**City of Pembroke Pines Fire Rescue**  
**Fire Prevention Bureau**  
 601 City Center Way 3rd FL  
 Pembroke Pines, FL 33025  
 PH (954) 499-9560

**FIRE SAFETY INSPECTION REPORT**

<b>Occupant Name:</b>	Heron Pond	<b>Inspection Date:</b>	1/19/2023
<b>Address:</b>	8311 Southwest 5 Street	<b>Inspected By:</b>	Victor Santos
<b>Suite:</b>	Bldg. - #8	<b>Property Use Type:</b>	Multifamily dwelling
<b>Occupant Number:</b>		<b>InspectionType:</b>	Annual Fire Alarm (FAS), Annual Fire and Life Safety Inspection
<b>Occ. Sq. Ft.:</b>	20000	<b>Number of AEDs:</b>	0

1.1 - 10.1.4.1.

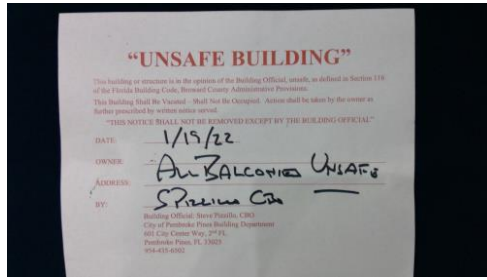
<b>Deficiency</b>		FL NFPA 01 2018 Chapter 10 General Safety Requirements	10.1.4.1 - Excerpt: Where structural elements have visible damage, the AHJ shall... (see photo 1.1)
-------------------	--	---	---

**Inspector Comments:** \*\*\*The noted structural damages have been referred to the City's Building Official and Structural Chief for evaluation of possible unsafe conditions. A site visit with structural inspectors and the Building Official to demonstrate areas of concern was conducted. Following the site visit, a structural engineer was consulted and in conjunction with the Building Official, deemed each patio/balcony area unsafe. The Building Official instructed Xochitl Alvarez, the property manager, to produce an analysis and proposal completed by a structural engineer for conditions and repairs within 48 hours. Each building and unit had an "Unsafe Building" notice posted on the front door as well as verbally communicated with residents who were home at the time. Residents were instructed that due to the unsafe conditions, they are to remain clear of the patio/balcony area until further notice is given.\*\*\*

Where structural elements have visible damage, the AHJ shall be permitted to require a technical analysis prepared in accordance with Section 1.15 to determine if repairs are necessary to restore structural integrity.
